Engineering Change Customer Notification

ECR/ECN 單號： ECR/ECN Number:	EO000050
日期： Date:	2023/10/02
變更者/郵箱： Author/Mail	Rita Lin
客戶端工程變更需求確認 : (signature) EC request confirmation by customer	請於 10 工作日內簽回，若超過 10 日未簽回將視為同意此變更 Please sign back within 10 working days, if you do not sign back within 10 working days, you will be deemed to agree to this change.
客戶端工程變更完成確認 : (signature) EC completion confirmation by customer	請於 10 工作日內簽回，若超過 10 日未簽回將視為已確認 Please sign back within 10 working days. if you do not sign back within 10 working days, it will be deemed as confirmed.

產品類別 Product Category	零件編號 Part Number
	PCB.SMAFST.2H.A.HT

4.變更圖例
Illustration of Change

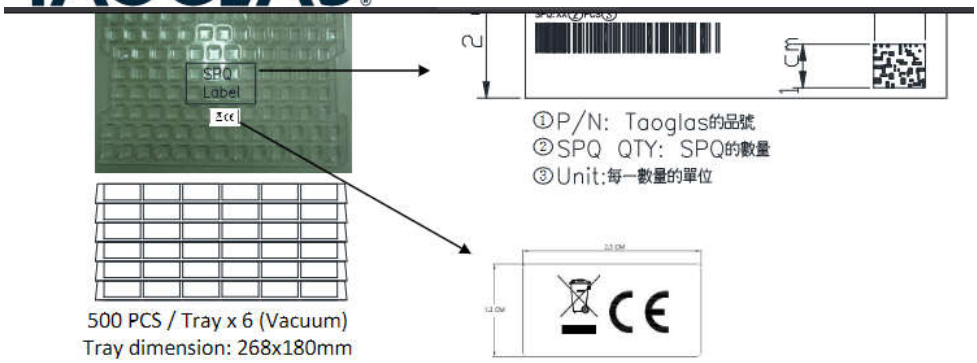
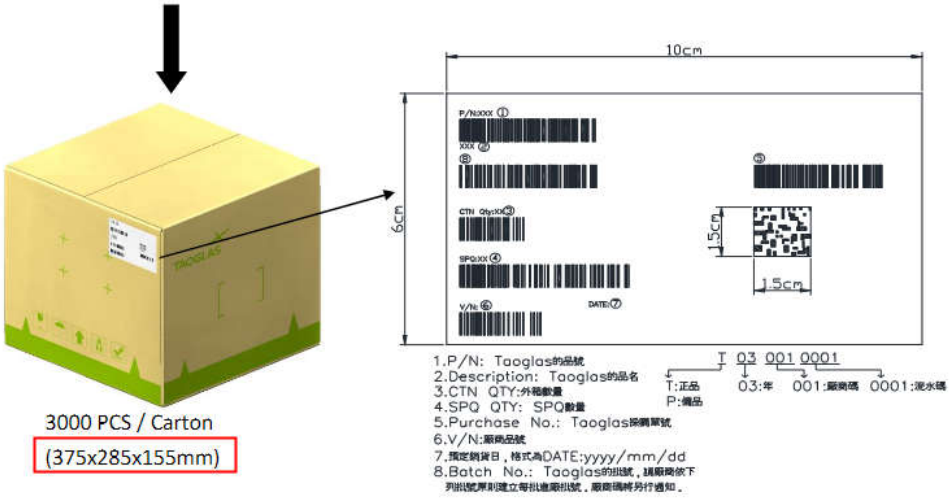
變更類型 Type of Change	■工程設計變更 Engineering Design Change	□生產製程變更 Production Process improvement
	□其他:	
變更原因 Reason for change	Change outside carton size to common size.	
變更說明 Description of Change	Change the outside carton size from 375*285*155 mm to 370*370*300 mm which is a common size in Taoglas.	
變更影響 Impact of change	□外觀 Appearance □功能 Function □規格 Specification □品質 Quality □可靠度 Reliability □法規 Regulations ■包裝 Package: □其他 Others: Add MFG plant	
	上述影響描述: Describe if above applies: Yes	No impact
預估轉換日期 Forecast Estimated Transition Date	Last buy (old product)	Running change
	New buy (new product)	TBC (after customer approval)

1. 變更前 / Before
   - Packaging revision: C.

- Packaging revision: D.
